# Hunter Indoor Sports Centre

Traffic Impact Assessment

Hunter Indoor Sports Centre,  
Turton Road, New Lambton

Issue: Ver08

Figure 4.1: PM outbound distribution diagram showing northbound egress

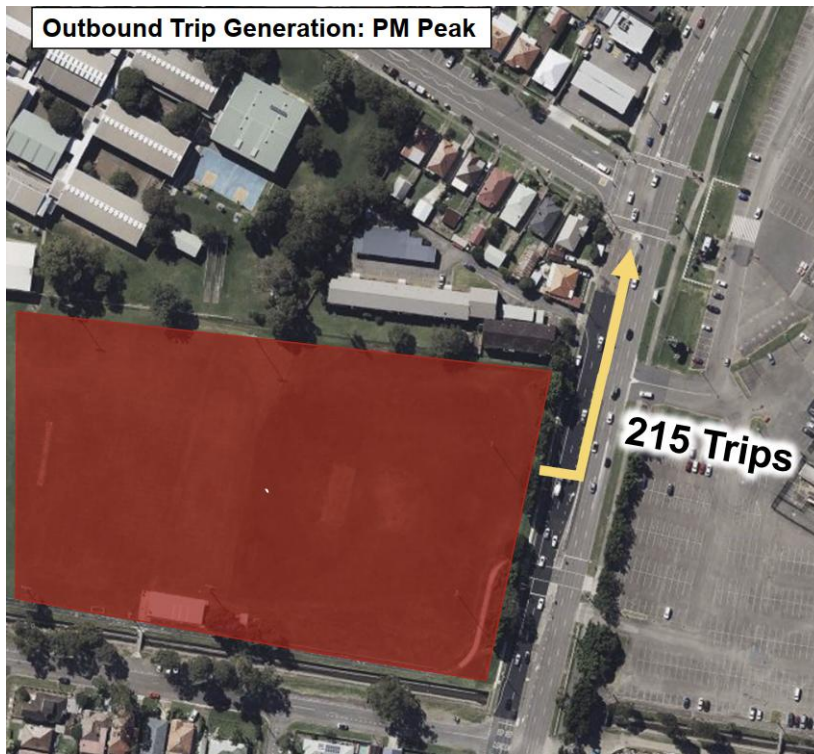
This section responds to the submission query questioning how "negligible delays" could occur at Turton Road / Young Road, given the HISC PM peak outbound demand (of ≈200+ vehicles/hour) and the fact that Turton Road / Young Road forms part of the access route for some trips to and from the site.

The site access is on Turton Road. During the weekday PM peak, the forecast left-turn traffic out of the site is 215 vehicles per hour, departing northbound on Turton Road, consistent with the adopted trip distribution for the project case. This means that this project traffic primarily adds to the Turton Road northbound through traffic north of Turton Road / Young Road, as shown in Figure 4.1.
